March 1, 2024

Mr. Paul Paquin, Chair
Town of Hull Conservation Commission
253 Atlantic Ave.
Hull, MA 02045

Subject: 51 Harborview Road
Hull, Massachusetts 02045
Response to Comments
CEC Project 334-762

CONSERVATION COMMISSION COMMENTS

OVERALL PLAN VIEW

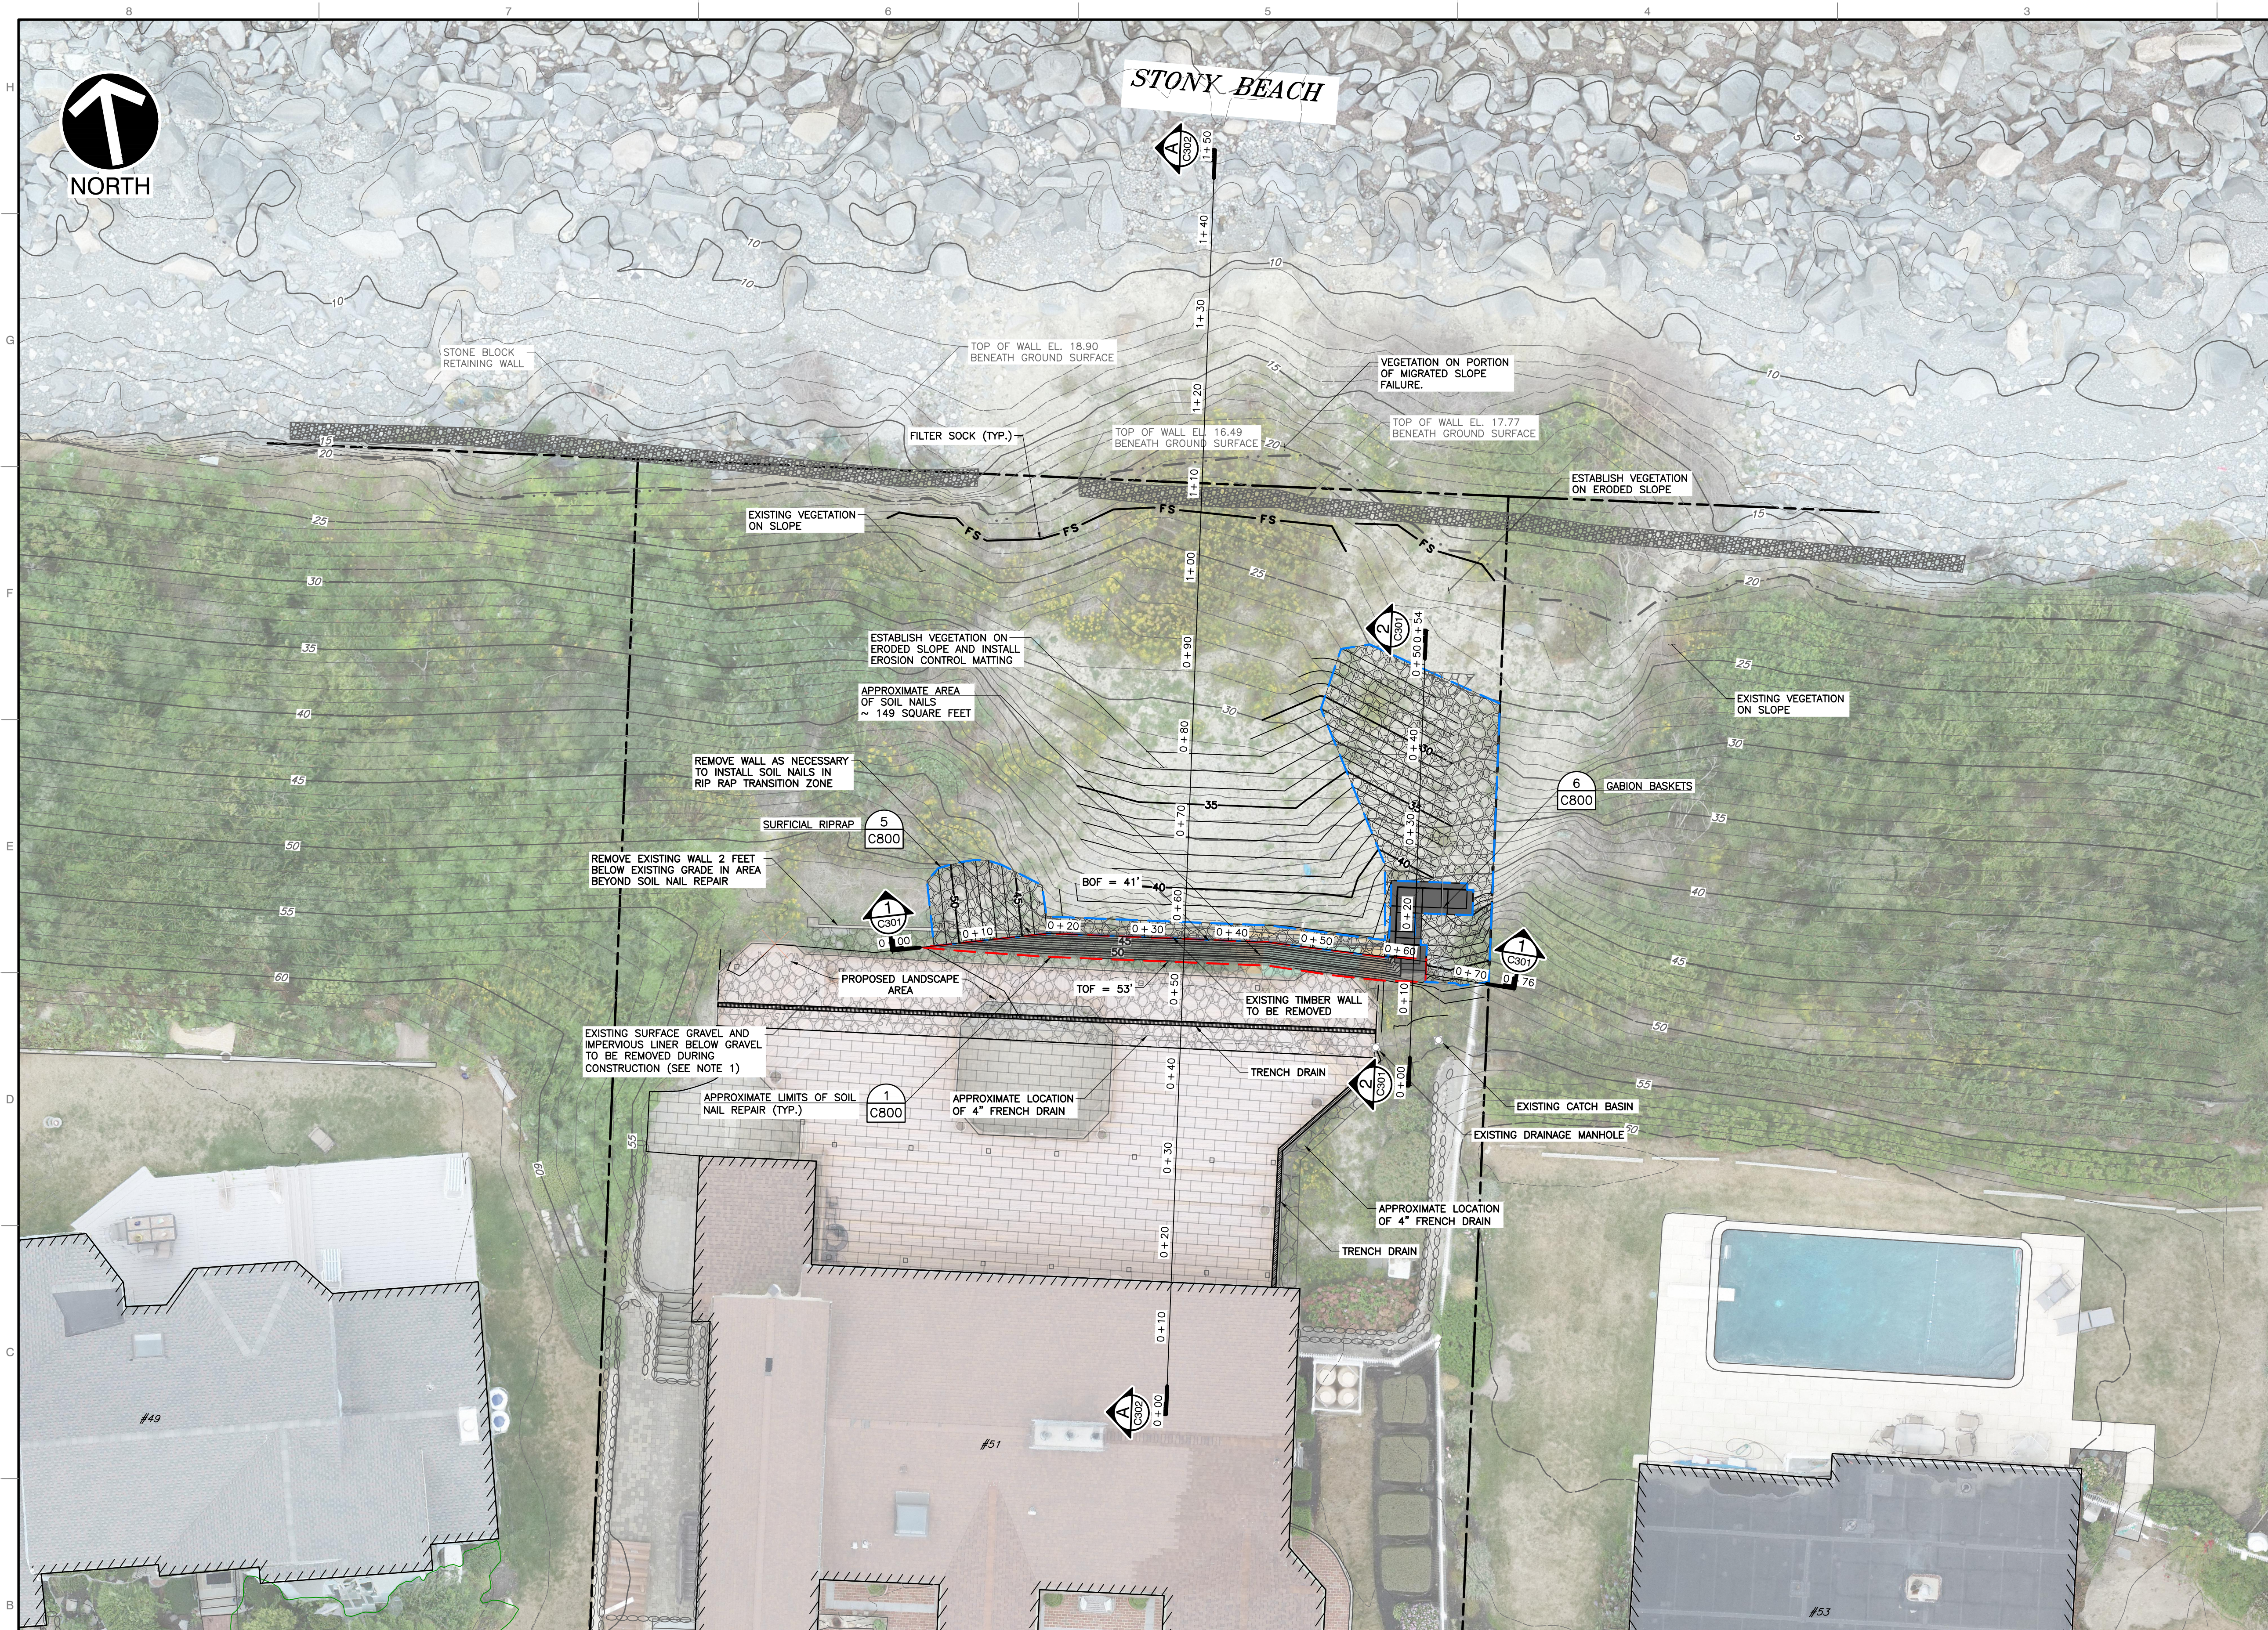
g. Include existing wall in design drawings and see comment #4 below (p. 9)

CEC Response: The existing wall has been added to the design drawings.

DETAIL 3
BEARING PLATE WITH STUD
N.T.S.

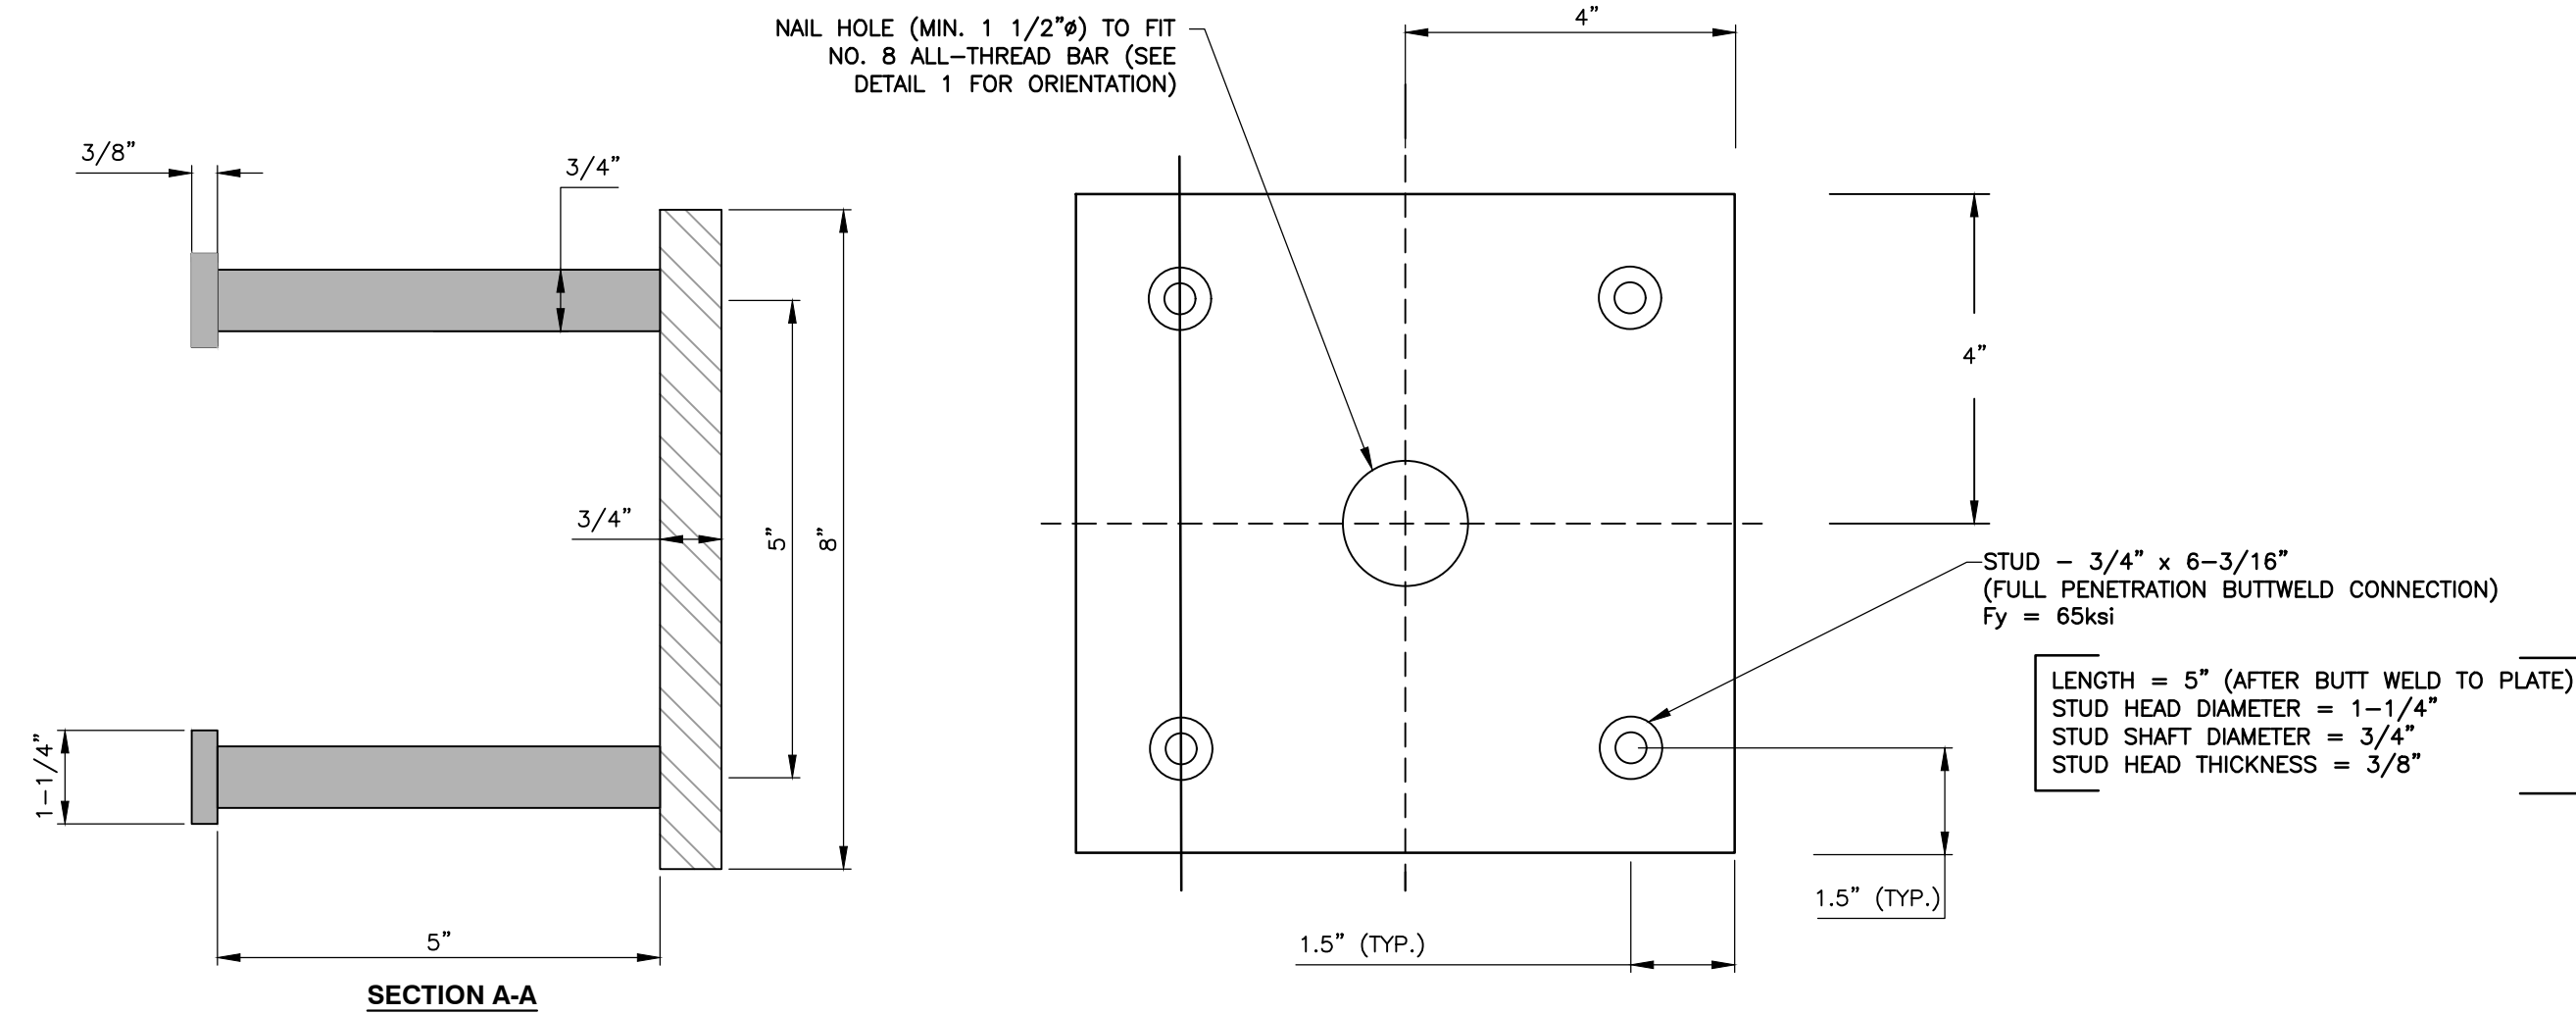
- d. Comment raised over concern that Soil Nail Structure (SNS) drainage strips can tend to clog-address how this will be mitigated/addressed. (2nd bullet, page 9)*

CEC Response: As stated in the GZA Memorandum dated January 18, 2024, installation of drainage strips are typical practice during construction of soil nail structures and have been proven effective for the life of the structure. The drainage strips specified in CEC's construction drawings have geotextile separation fabric fused to the inner core to minimize the migration of fine particles into the drainage system. The drainage system will include weepholes installed at the base of the soil nail facing that ties into the rip rap berm proposed at the base of the facing. The weepholes can be cleaned out from the ground surface periodically, if necessary. However, the strip drain portion of the drainage system will be inaccessible after construction due to placement of the shotcrete.
